15 June 2017

Healthy Waters
Auckland Council
Private Bag 92300
Auckland 1142

Subject: Further information requested under clause 23 First Schedule of the Resource Management Act 1991

The following information is provided in response to the clause 23 request received on the 30 April 2018.

Figure 1: Peak Flow Hydrograph Upstream of Falls Road Bridge for 10 Year ARI

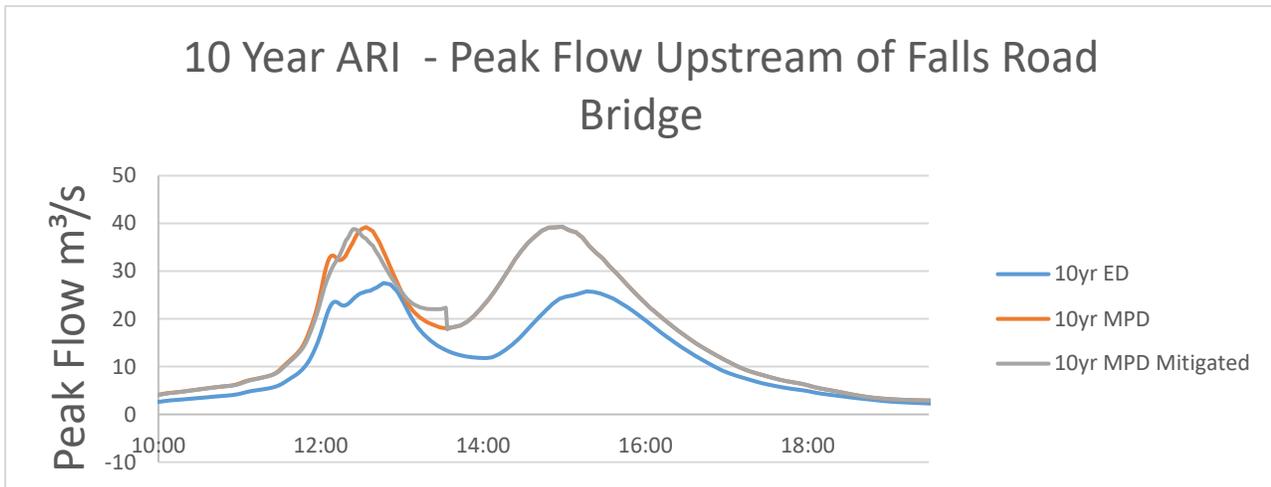
Provide an assessment of the impact of post-development flood flows in Stubbs Stream on the frequency (if any) of stormwater overtopping of Falls Road for up to a 10 year storm event.

Following a meeting between Healthy Waters and Chester personnel it was agreed that Chester would update their existing hydrological model to assess the differences between the existing development (ED) and maximum probable development (MPD) scenario for the Stubbs Stream Catchment, including an assessment of the effects of peak flow mitigation measures applied to sub-catchments within the Structure Plan area. The 2 year, 5 year, 10 year and 20 year annual recurrence interval rainfall events were assessed.

Healthy Waters provided time series flow extracts from the wider Mahurangi Catchment model, to account for the spill from the Mahurangi River Catchment into the Stubbs Farm Stream catchment. The time series input was included in the Chester Hydrological model as a manual discharge gauge input.

The outputs from the hydrological model are summarised in Table 1.

In all cases the MPD peak flows are significantly larger than the corresponding peak flows from the ED scenario, due to the combined effect of increased rainfall due to climate change and increased impervious coverage in the catchment.

The peak flow hydrograph at the Falls Road Bridge displays a distinctive double peak in all the modelled scenarios, the peak flow hydrograph for the 10 year ARI event is depicted in Figure 1. The first peak arriving at the falls road bridge corresponds to flows from the Stubbs Farm Structure Plan area and from catchments to the north east of State Highway 1 which also contribute to Stubbs Farm Stream. The second peak occurs much later and corresponds to flows spilling from the much larger Mahurangi River Catchment. The peak from the Mahurangi River Catchment is delayed due to the size of the contributing catchments and extended time of concentration.

The maximum peak flow of the smaller rainfall events (2 year and 5 year ARI) is dictated by flows from the Stubbs Farm Stream Catchment, where the magnitude of flows spilling from the Mahurangi River Catchment is less. In the 10 and 20 year ARI events the maximum peak flow is dictated by the large volume of water spilling from the Mahurangi River Catchment.
